## MEMORANDUM

### 28015 SUMMIT DRIVE WOODLAND PERMIT - PBR22-0530 **NATURAL FEATURES**

То:	Nina Schaffrath, Account Clerk City of Novi
From:	Kerry Gray, Principal Consultant
	Davey Resource Group
CC:	Barbara McBeth, City of Novi City Planner
	Lindsay Bell, City of Novi Senior Planner
	Christian Carroll, City of Novi Planner
	Rick Meader, City of Novi Landscape Architect
	Ben Peacock, City of Novi Planner
	Heather Gendron, Spalding DeDecker
	Ted Meadows, Spalding DeDecker
	Sydney Waynick, Spalding DeDecker
	Douglas Repen, The Mannik & Smith Group, Inc.
Date:	February 2, 2023 (revised March 2, 2023)
RE:	28015 Summit Drive - Single Family Residential Plot Plan Woodland Review #2 – PBR22-0530

### 28015 SUMMIT DR, PBR22-0530 FOR A WOODLAND PERMIT

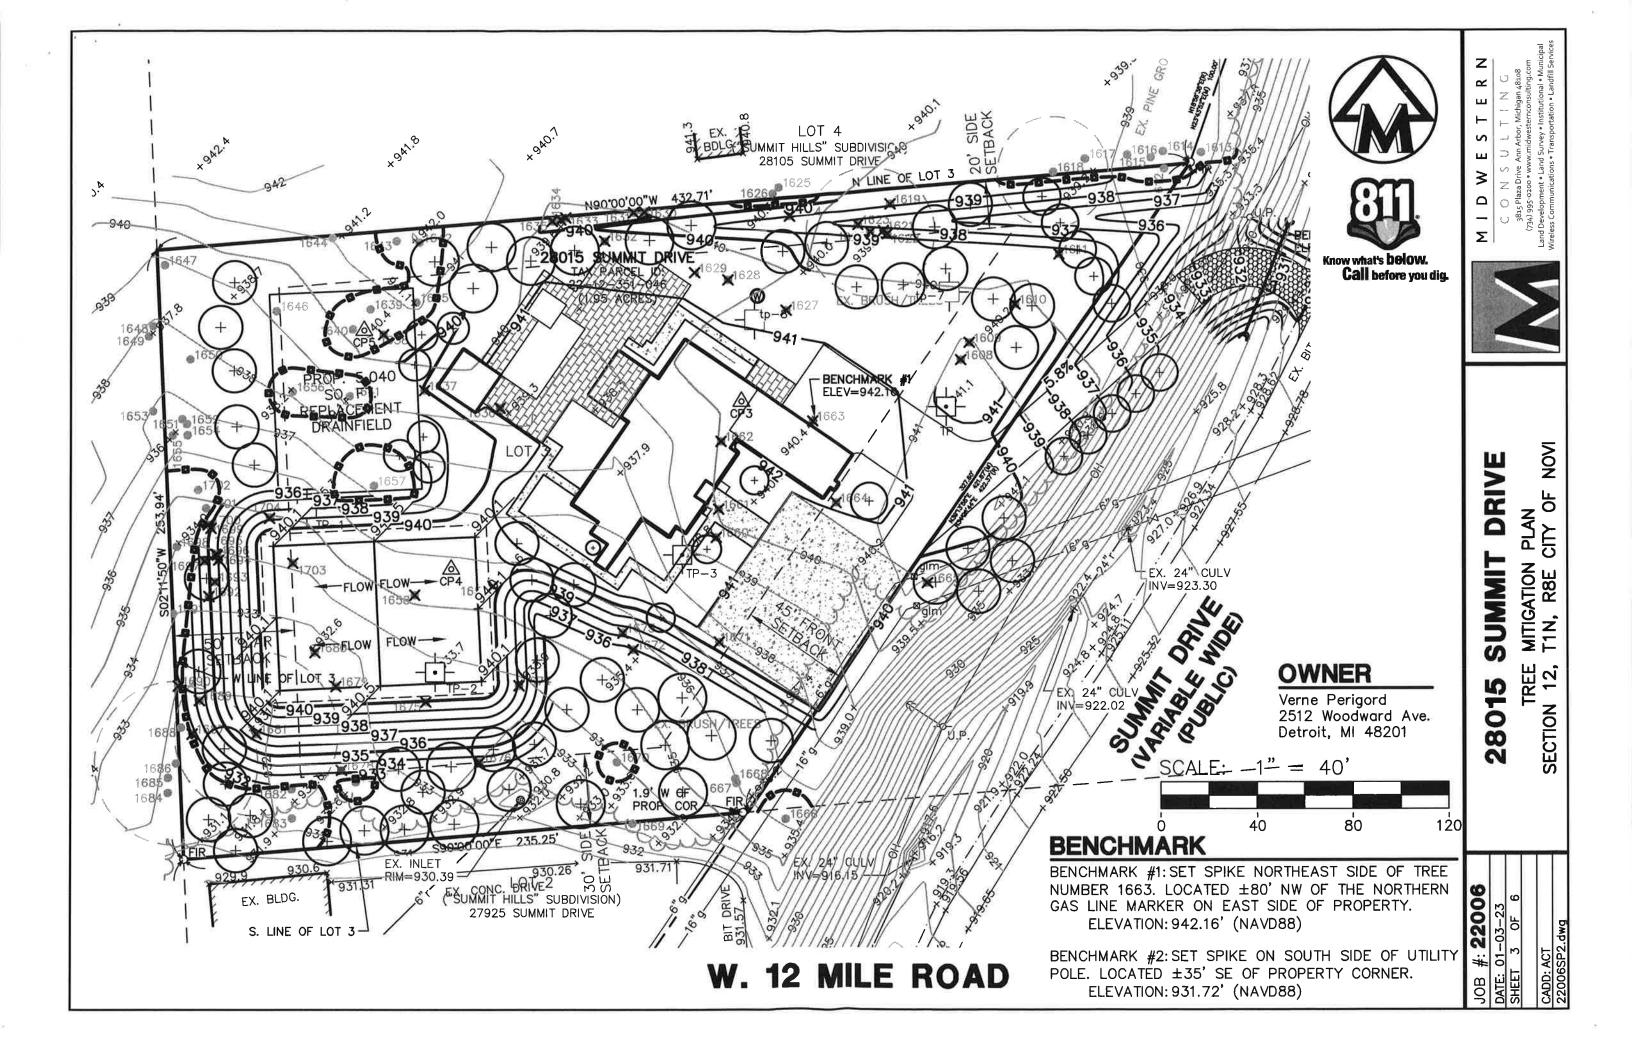
- Invasive Species. On Sheet 4 of the plot plan, it states that seven (7) trees that are considered invasive species are exempt from regulations. This is incorrect all trees in a regulated woodland 8" in diameter (DBH) or greater are regulated woodland trees. The correct mitigation calculations are provided in comment #3. (*This comment was also in review letter #1*).

The plan shows 11 trees being planted off-site in the public ROW. This is not permitted – all trees removed must be planted on-site. Any tree removals that do not fit on-site can be mitigated through payment into the City of Novi Tree Fund at a rate of \$400/tree.

- a. Tree protection fence must be installed at the perimeter of the critical root zone (CRZ) of all regulated trees to be preserved on site and must remain in place for the duration of the construction project. The critical root zone is located one (1)-foot outside the dripline (edge of canopy) of preserved trees. On Sheet 3 tree protection fencing is shown around some protected trees; however the trees along the northeast property line do not have tree protection. Please revise the plot plan to show the location of the tree protection fence.
